D206-642-241
Job Sheet 187718

Part Name: Remplacement Skidtube, High Gear with Standard Wearplates Fits LH or RH

DRAWING NO. D2650	TITLE 206/407 SKIDTUBE ASSEMBLIES	REV. F	DART AEROSPACE LTD ENGINEERING ORDER		D.E.O. NO. D2650-F-1	SHEET NO. SHEET 1 OF 1	SCALE NTS
DRAWN <i>[Signature]</i>	CHECKED A.P.	MFG. APPR. <i>[Signature]</i>	APPROVED <i>[Signature]</i>		DE APPR. <i>[Signature]</i>		
DATE 12.10.12	DATE 12.10.22	DATE 12.10.22	DATE 12.10.22		DATE 12.10.22

CHANGE C'BORED WELDED CROSSBOLT SPACERS TO SWAGED SPACERS

DETAIL G

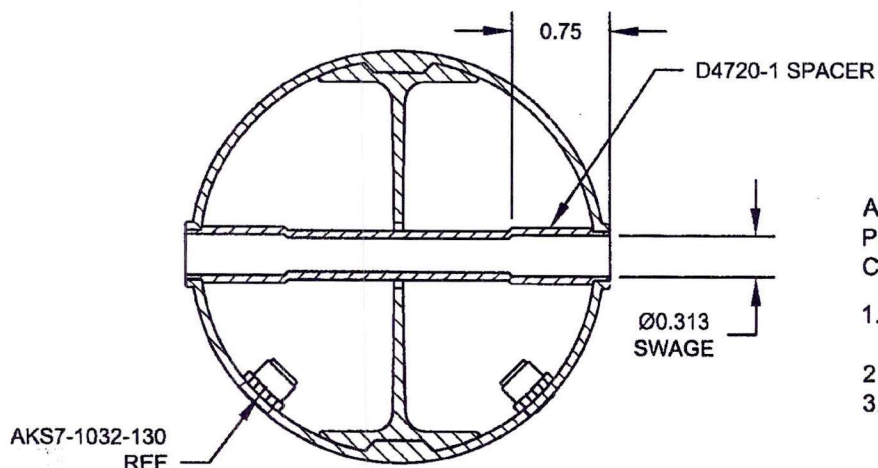
ADD DETAIL G BELOW, WHICH IS THE SAME SECTION VIEW AS DETAIL D OF DWG.

C'BORED HOLES ARE **NOW SWAGED** PER DETAIL G BELOW. FOR THE Ø0.375 HOLE THAT IS NOT C'BORED, WELD PER DETAIL D OF DWG (SEE AMENDED DETAIL B FOR REFERENCE).

AFTER DRILLING AND BENDING ASSEMBLY
PERFORM THE FOLLOWING FOR Ø0.375 HOLES THAT ARE
CURRENTLY C'BORED:

1. INSERT D4720-1 SPACER, 16 PL (-1) OR 17 PL (-3)
OR 19 PL (-5) OR 23 PL (-7)
2. SWAGE TO Ø0.313 X 0.75 DP PER QSI 002
3. TRIM / GRIND FLUSH PER QSI 002
